ENGINE - HP TURBINE ROTOR AND STATOR ASSEMBLY - PROVIDE NEW STAGE 1 HPT DUCT SEGMENTS,  
BAND SEGMENTS, SUPPORTS, SEALS AND BOLTS - CATEGORY CODE 7 - MOD.ENG-72-0339

V2500-ENG-72-0339

Location of the Stage 1 High Pressure Turbine Duct Segments And Band Segments  
Fig.1

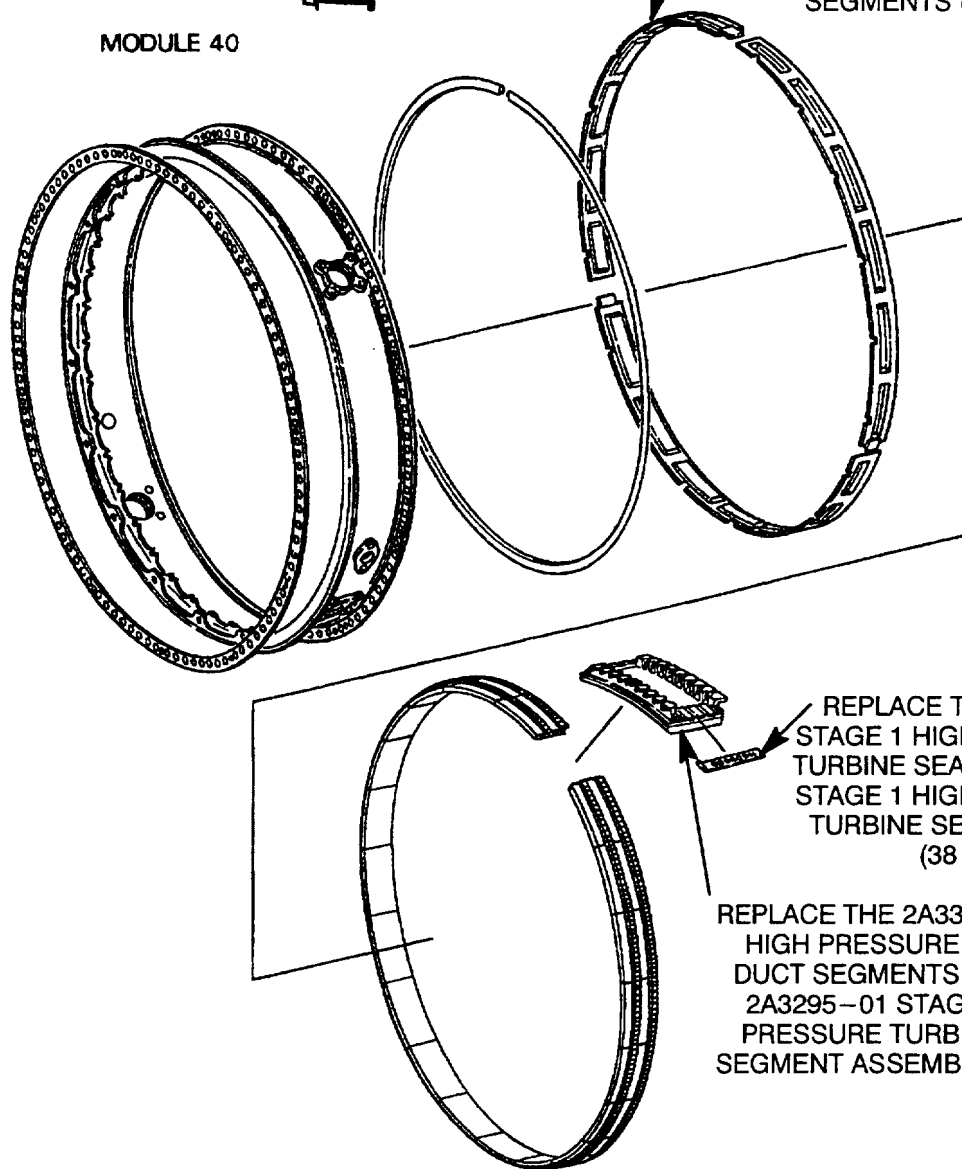
- (a) Replace the 2A3361 Stage 1 HPT Duct Segments with the 2A3295-01 Stage 1 HPT Duct Segments (38 off).
  - (b) Replace the 2A0183 Stage 1 HPT Duct Seals with the 2A1701 Stage 1 HPT Duct Seals (38 off).

REPLACE THE 2A0184-01 AND  
THE 2A0187-01 STAGE 1 HIGH  
PRESSURE TURBINE BAND  
SEGMENTS WITH THE  
2A3297-01 STAGE 1 HIGH  
PRESSURE TURBINE DUCT  
SEGMENTS (3 off)

Location of the Stage 1 High Pressure Turbine Cooling Duct Assembly  
Fig.2

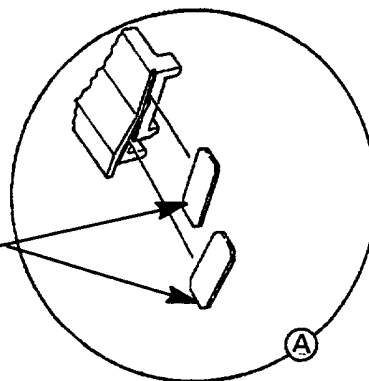
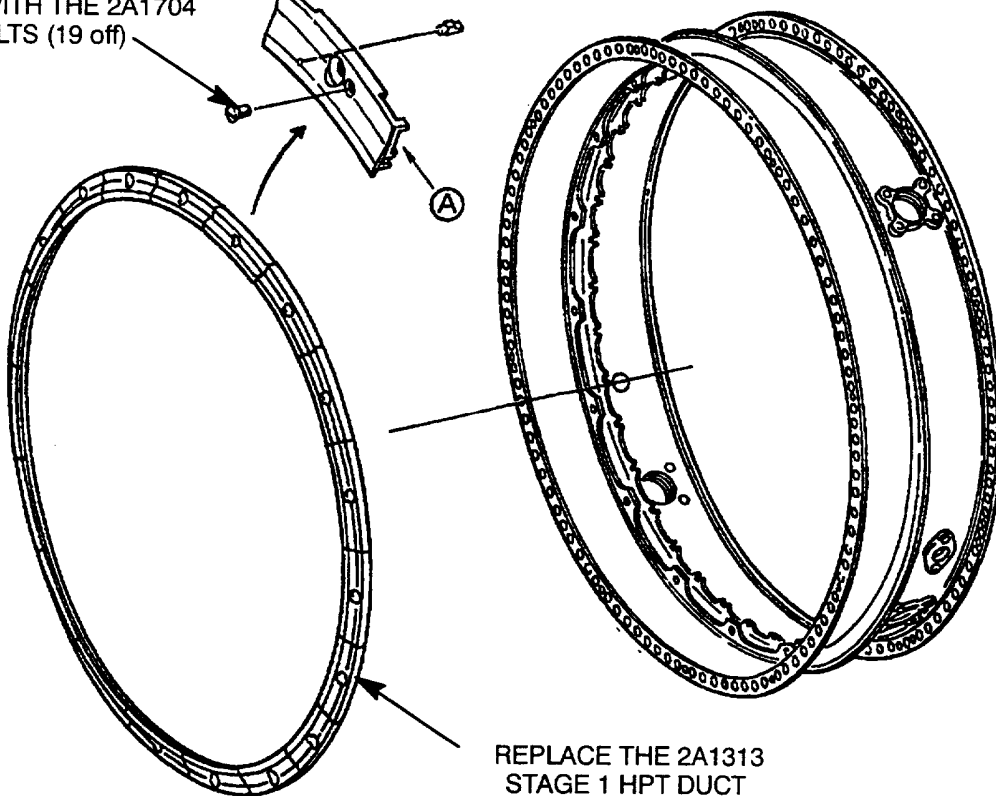
REPLACE THE 2A0180-01  
AND THE 2A0181-01  
SEALS WITH THE 2A3299  
SEALS (19 off)

REPLACE THE ST1359-12  
BOLTS WITH THE 2A1704  
BOLTS (19 off)

REPLACE THE 2A1313  
STAGE 1 HPT DUCT  
SUPPORTS WITH THE  
2A3296 STAGE 1 HPT  
DUCT SUPPORTS (19 off)
